**TO: M. JAWORSKI, S. GERHART**

**FROM: M.L. REINKE**

**SUBJECT: MODIFICATION OF HEAT FLUX REQUIREMENTS FOR CSAS**

Figure 1: Equilibrium and heat flux simulation for TT 2-04a, which forms the basis for CASE #3 in the CSAS heat flux requirements. This has the strike point the farthest up the CSAS and the highest angle of incidence

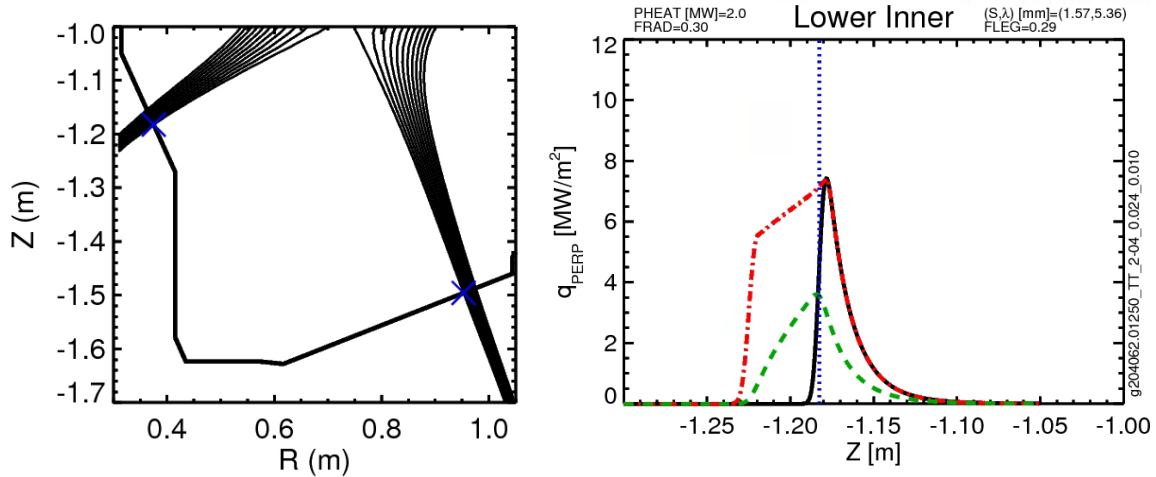
The lower single null L-mode plasmas explored in PFCR-MEMO-008 set the SRD requirements for the CSAS. The two driving are shown in Figure 1 (Case #3) and Figure 2 (Case #1). These represent the highest heat flux and highest angle of incidence, respectively. In addition Case #3 is also the simulation, TT\_2\_04a, corresponding to the largest lower triangularity of the L-mode scan at  $TRIBOT=0.415$  and the strike point with the smallest  $|Z|$ . The Case #2 in the SRD for the CSAS (Table 4.5-1) does not correspond to a scenario which should drive or challenge the design. It is a shallow angle of incidence case at low power. If, after adjustment of designs following these new flux requirements, 'fishscaling' is still deemed to be necessary any shallow angle of incidence cases where there may be shadowing be evaluated post-FDR when developing operational guidance for CSAS operation.

The shape of the time averaged profiles shown in Figure 1 and Figure 2 do not well match the 'Extent' feature used to specify spatially localized heat fluxes. In fact they are closer to isosceles triangles instead of right triangles, but these simulations do not reflect empirically realizable scans.

- A. Add to Table 4.5-1 an Extent of 8 cm for all rows.
- B. Add to Table 4.5-1 a Range of Application of  $|Z| > 1.1$  for all rows.
- C. Eliminate Case #2 in Table 4.5-1
- D. Eliminate Requirement 4.5-b and the Energy row from Table 4.5-1

Never-the-less, it is suggested that an extent of 8 cm be used, which for CSAS tiles of poloidal length of 13-14 cm results in a more than a factor of three reduction in energy. This is still conservative, but is expected to eliminate engineering challenges in present designs identified at the PDR. Future detailed modeling post-FDR will be done to help establish operational limits including scenarios that have 'spillover' heat flux from the IBDV which as discussed in PCFR-MEMO-008 "should not drive PFC requirements, they represent a usage scenario for which the compatibility should be evaluated based on delivered CSAS designs". Note that this 'Extent' is assumed to be in the common flux direction, e.g. the heat flux profile extends to smaller  $|Z|$ , and should be measured along the surface.

Figure 2: Equilibrium and heat flux simulation for TT 2-05b, which forms the basis for CASE #1 in the CSAS heat flux requirements. This has the highest time averaged heat flux.

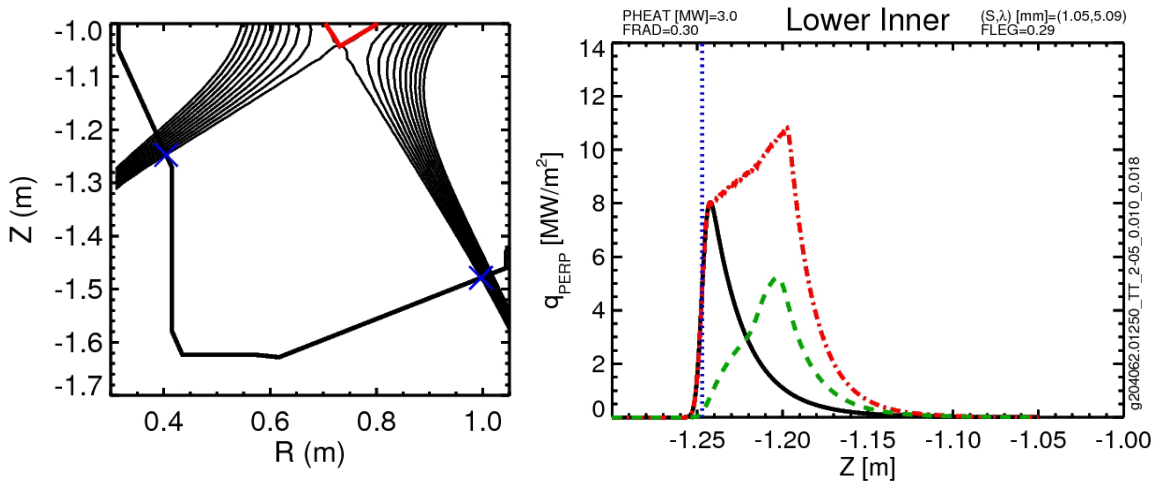
Each CSAS, combining both the Row 5 and Row 6, is estimated to have a surface area of  $0.61 \text{ m}^2$ . Thus, for the Case #1, where  $0.63 \text{ MW}$  of power is directed to the inner target (assuming  $P_{\text{NBI}}=3 \text{ MW}$ , 30% radiated, 30% to the inner target), an assumption  $5.2 \text{ MW/m}^2$  over the whole surface vastly over estimates the input power. In addition, the Case #3 shown in Figure 2 shows that this power is unlikely to load the region near the top of Row 6 near the CSAS/FW interface. This implies the heat flux requirements for tiles that are limited not by surface temperature but by sub-surface stress states driven by energy input, e.g. 'bowing', are extremely conservative and should be relaxed.
